10 March 2023

**RE: 46 PRINCE ALFRED PARADE, NEWPORT NSW 2106
BCA AND DDA COMPLIANCE STATEMENT FOR DA SUBMISSION**

This report has been prepared based on a review of the preliminary DA architectural plans prepared by MCHP Architects:

Ground floor

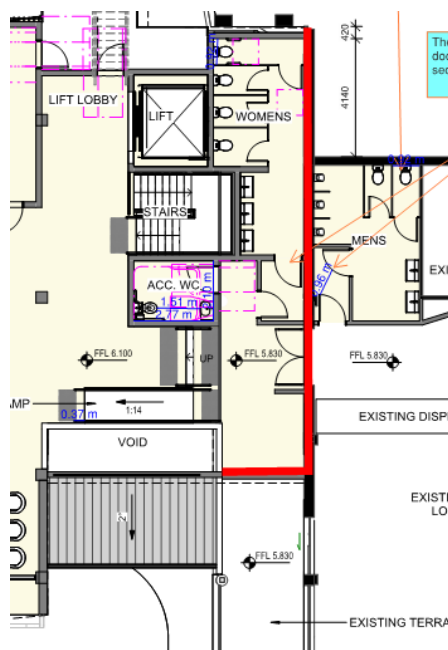
The new proposed extension is required to be fire separated by a fire wall achieving an FRL of 180/180/180; details are to be included in the design as nominated below on the respective levels.

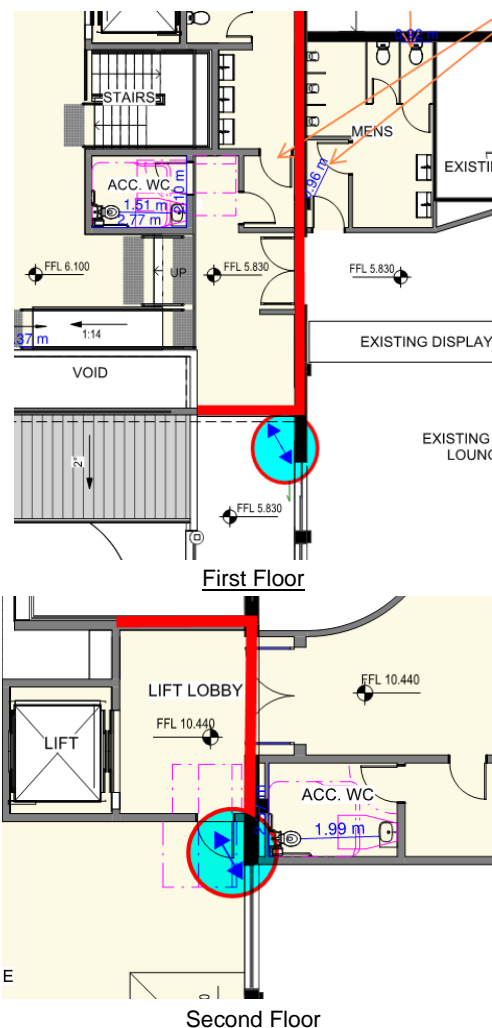
The building footprint is over inter-allotment boundaries as detailed below, a fire engineered solution is to be prepared to justify not protecting openings or fire-rate external walls where they are exposed.

As circled in blue below, the openings in the external walls and openings in adjacent fire compartments are to be justified as a fire engineered performance solution.

(b) Path of travel to ambulant toilets

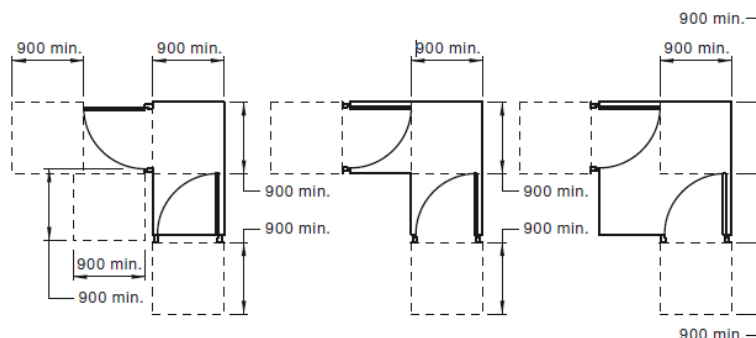
D4D2 (Prev. D3.1)	<p><u>General Building Access Requirements</u></p> <ul style="list-style-type: none">+ Access is provided to and within all areas unless exempted under D3.4.
D4D3 (Prev. D3.2)	<p><u>Access to Buildings:</u></p> <ul style="list-style-type: none">+ Access is to be provided from the main points of pedestrian entry.+ All pedestrian entrances are to be accessible. <p>To be addressed as a Performance Solution</p> <p>An accessway cannot be provided from street level to the main pedestrian entry due to topography issues. Recommend performance solution be prepared by a suitably qualified access consultant.</p>
D4D4 (Prev. D3.3)	<p><u>Parts of Buildings to be Accessible:</u></p> <ul style="list-style-type: none">+ Every ramp and stairway (except for fire-isolated stairways) are required to comply with AS 1428.1 – 2009.+ Accessways must have turning and passing space complying with AS 1428.1 – 2009.+ Compliance is readily achievable with the requirements of AS 1428.1 – 2009 as required by this part. <p>Does Not Comply and needs to be addressed at Construction Certificate Stage</p> <p>From the first-floor male and female sanitary facilities the airlock doors are required to be provided with a clear 900mm x 900mm clear passageway as indicated in the below snippet between successive doors in path of travel to an ambulant toilet.</p> <p>Doorway circulation to the sauna room on the ground floor is obstructed from the proposed FF&E.</p>

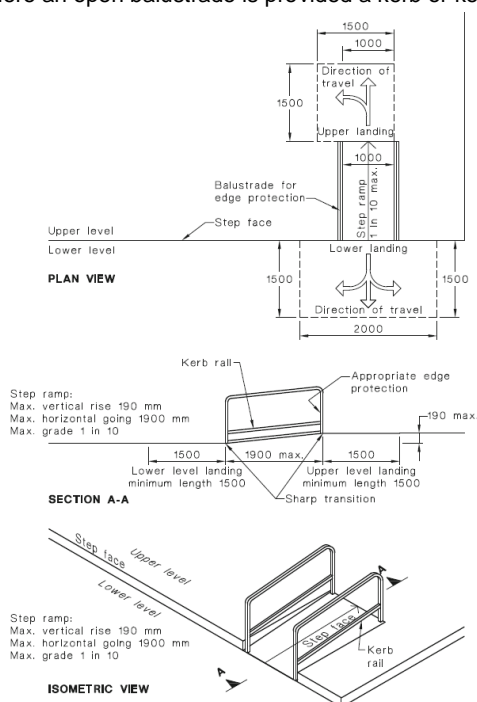
General Note

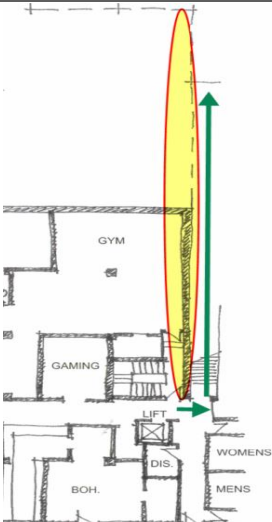
D2D12 (Prev. D1.7)	Discharge of Fire isolated exits	The discharge of the existing Eastern Fire stair serving all levels does not discharge to open space or a complying enclosed area	Re-configure the stairway to discharge to open space or seek fire engineered performance solution, may require creation of a sterile lobby or space.	 
		The path of travel from the Eastern Fire stair, to open space involves passing within 6m of unprotected openings of the same building (windows in eastern façade).	Provide window protection to windows within 6m of path of travel, alternatively seek fire engineered performance solution, which may involve an option to go in alternative directions from the discharge of the stair.
